**ADDENDUM NO. 1**

December 10, 2020

**THE CITY OF GREENVILLE NC  
FIRE RESCUE NO. 1 BAY EXPANSION  
500 S GREENE ST, GREENVILLE, NC 27834  
ARCHITECTS PROJECT NO. 1667**

**1 LIGHTING PLAN - NEW WORK**  
 1/8" = 1'-0"

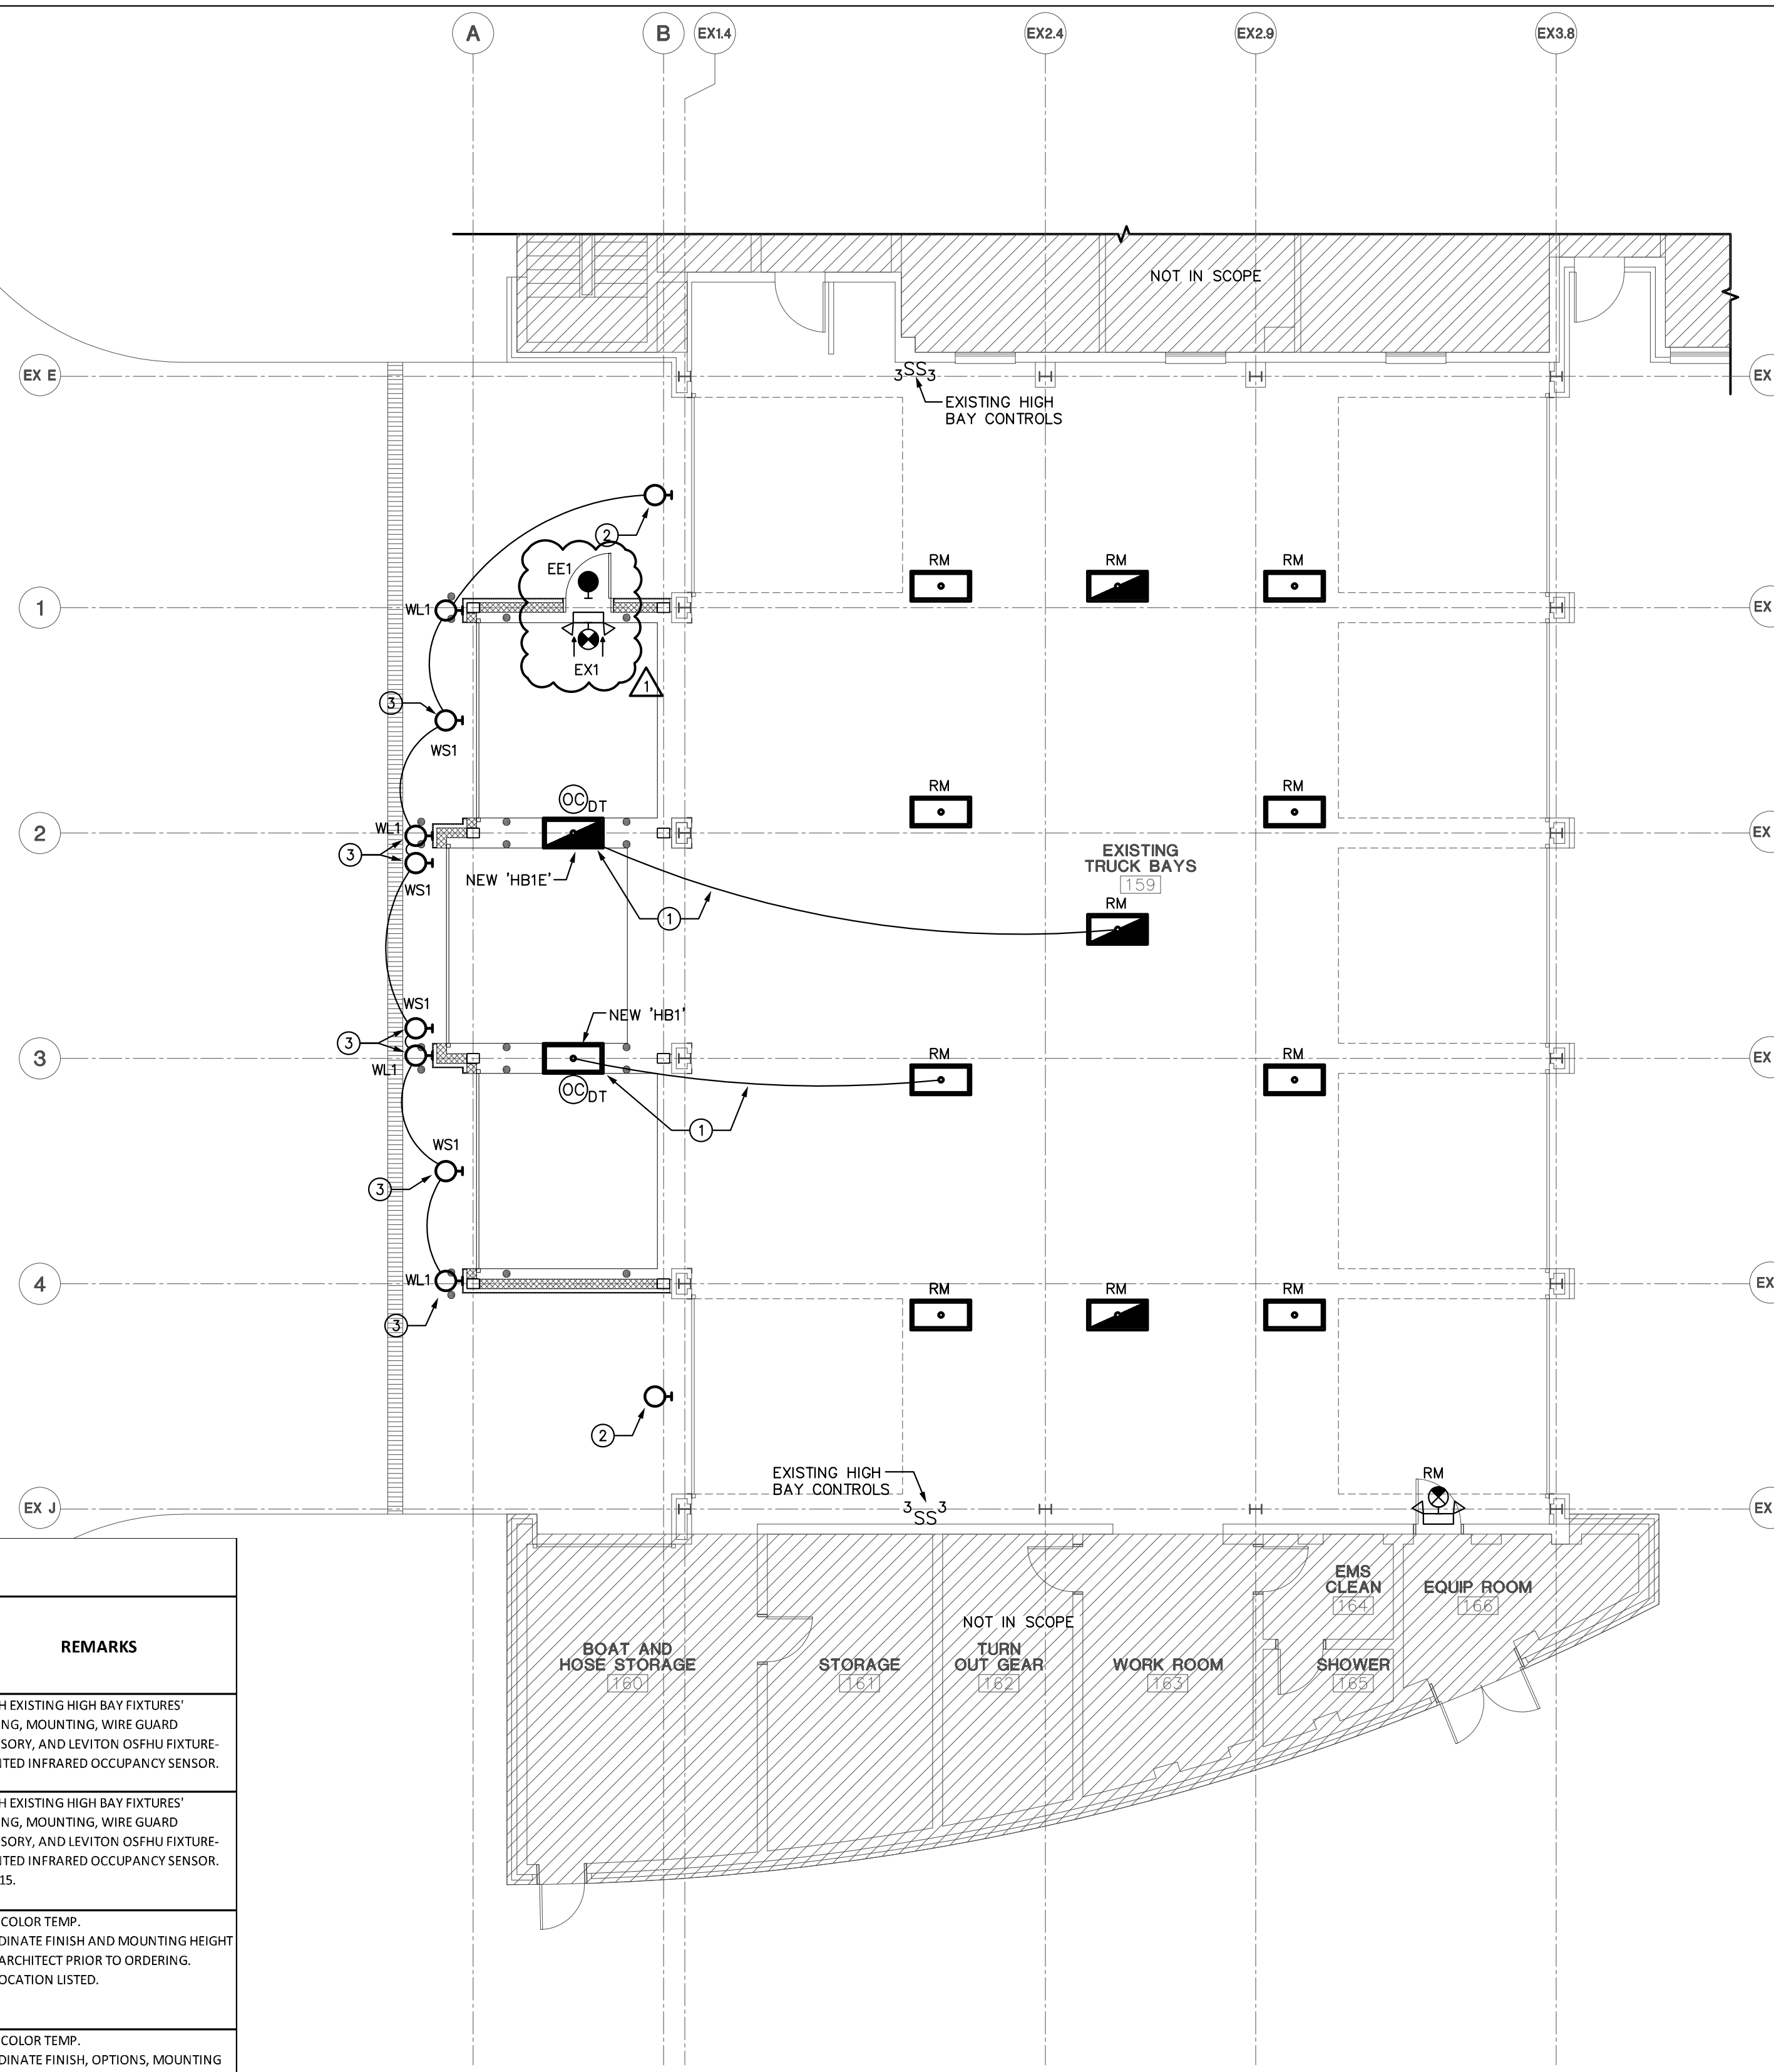
- 10.00** New Emergency Light added (see attached revised sheet 10.00 and replace the previous sheet).
- 10.21** New Emergency Light added, color to be selected by Architect during construction (see attached revised sheet 10.21 and replace the previous sheet).
